TO: All Bidders
FROM: Linda Wolf, CPA, Purchasing Agent
DATE: July 28, 2017
SUBJECT: Addendum #3 NUTRITION BUILDING

ESSEX COUNTY NUTRITION PROGRAM
- PROPOSED FACILITY

FINIAL
DETAIL
REVISIONS

1
SK-01

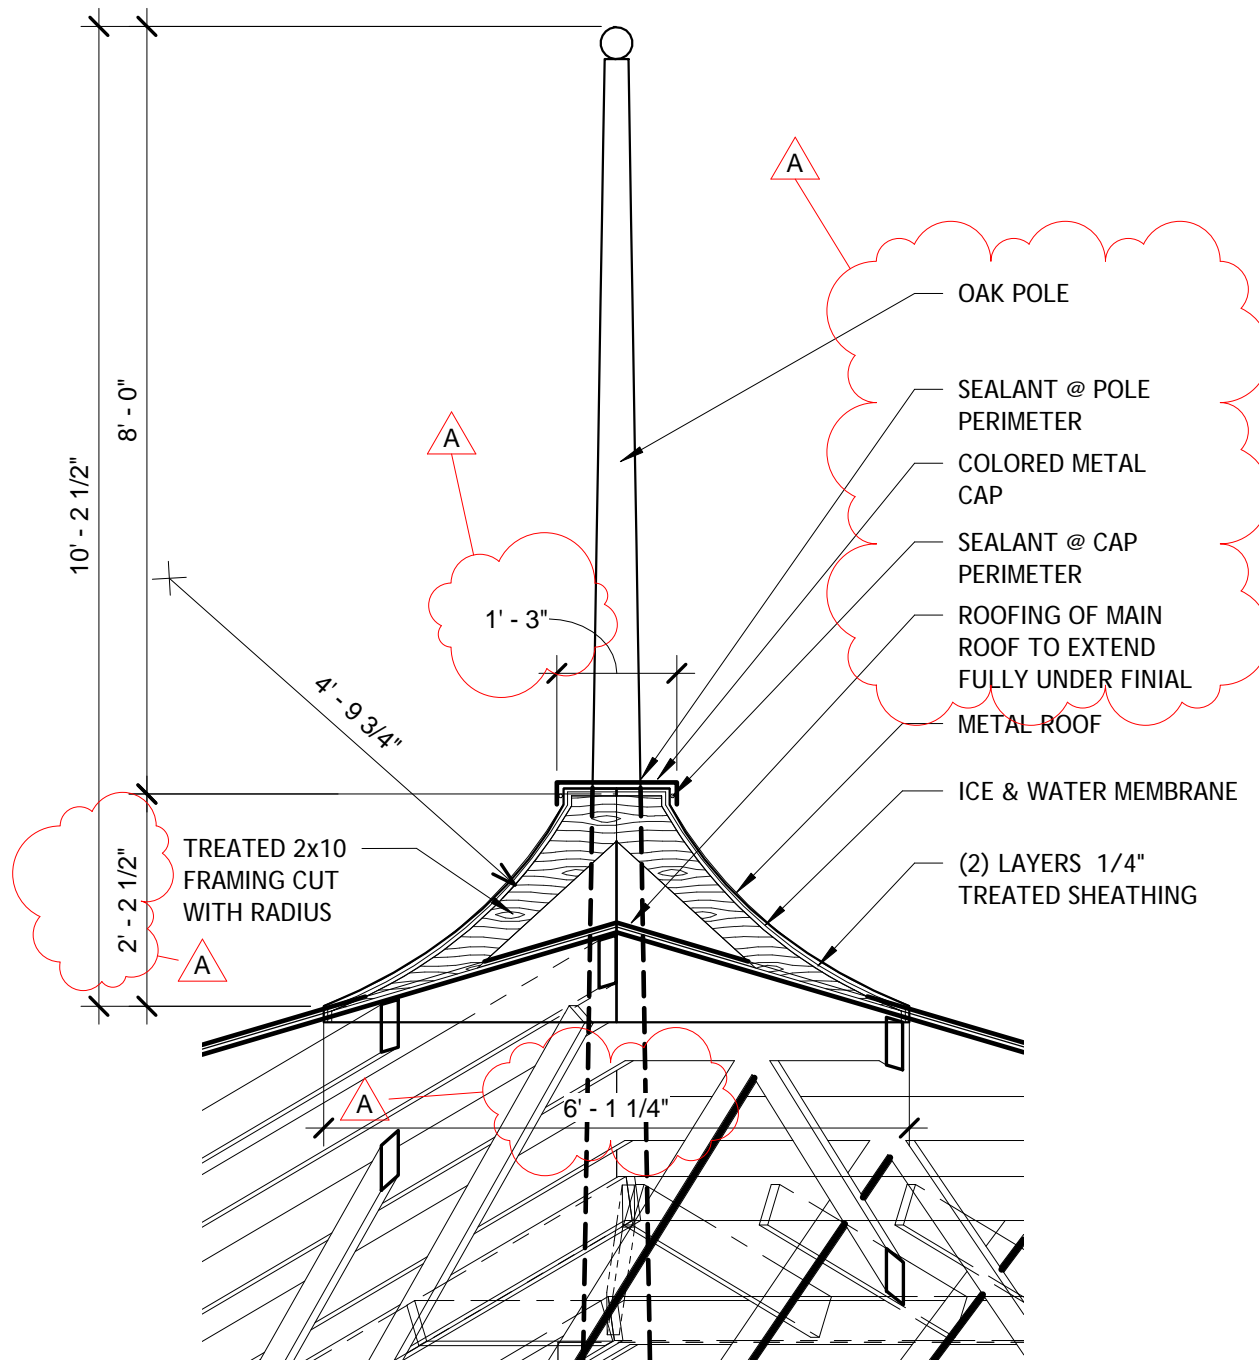
7. Are there any details for the metal roofing at the finials with details at the finial post, at the transitions between the curved panels and the straight panels, and at the curved panels to the ridge transition.

8. Are the finial curved roofs not actually joining the flat roof, but to be raised on cupolas?

See the attached sketch SK-01 and Picture of an existing building on premises for reference.

See the attached sketch SK-01 and Picture of an existing building on premises for reference.

- OAK POLE
- SEALANT @ POLE PERIMETER
- COLORED METAL CAP
- SEALANT @ CAP PERIMETER
- ROOFING OF MAIN ROOF TO EXTEND FULLY UNDER FINIAL
- METAL ROOF
- ICE & WATER MEMBRANE
- (2) LAYERS 1/4" TREATED SHEATHING

FINIAL SECTION @ 45° - SKETCH
